RE: **Project Name:** LCCC Generator Replacement
 Project Number: 240002936
 Project Location: Lemon Creek Correctional Center (LCCC), Juneau, Alaska
 New ITB Deadline: **November 17, 2023 @ 2:00 p.m., Local Time**

Addendum # Three (3)

Figure 3: Location of new remote annunciator.

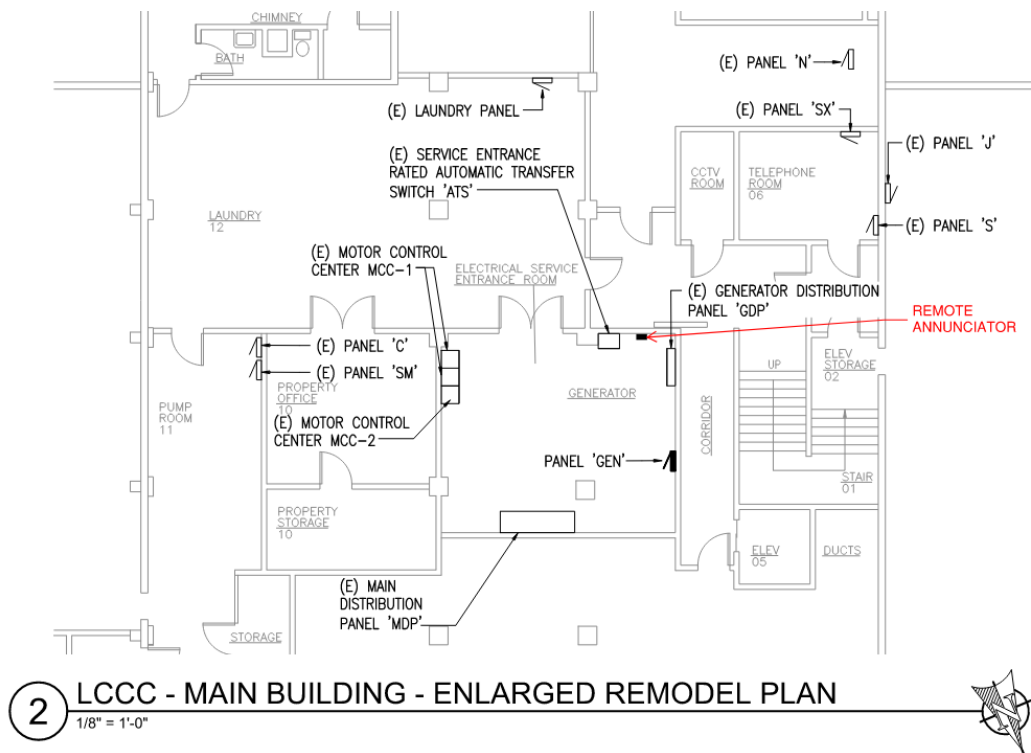
Q: Where is the remote Annunciator to be located, can this be identified on the site drawing?

A: *Remote Annunciation to be in the in room "GENERATOR" adjacent to the existing ATS. See figure 3 for location.*

Figure 4: Typical housekeeping pad detail.

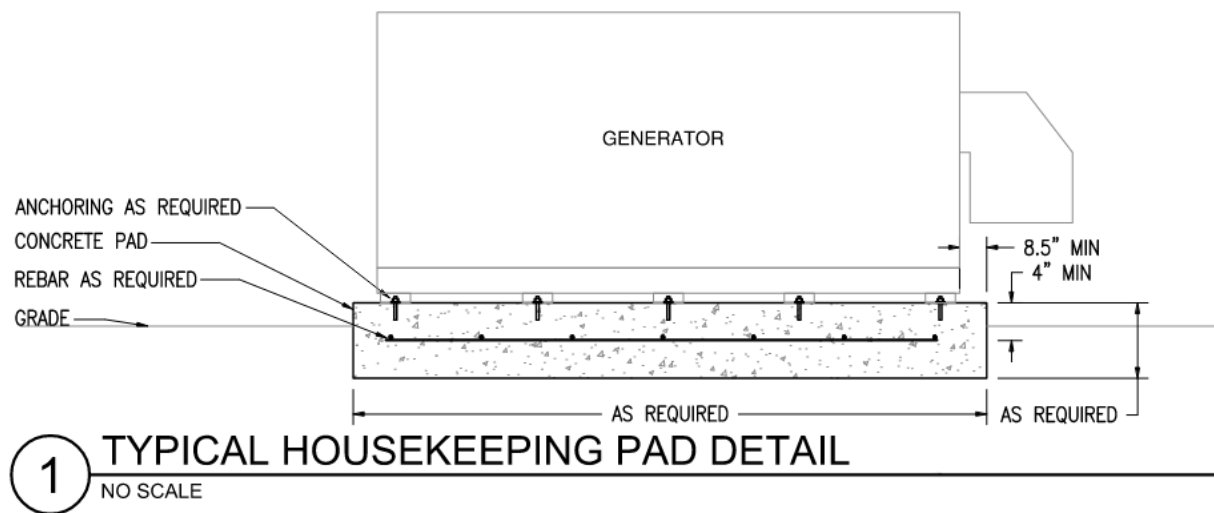
Q: The new generator is shown relocated to the exterior. There is no housekeeping pad noted on the drawing. Is there a new Pad intended for the new generator? Please provide details.

A: For contractor convenience we have provided a typical detail. Housekeeping pad and equipment anchoring design shall be provided by the contractor in accordance with specifications 26 05 48. See figure 4.
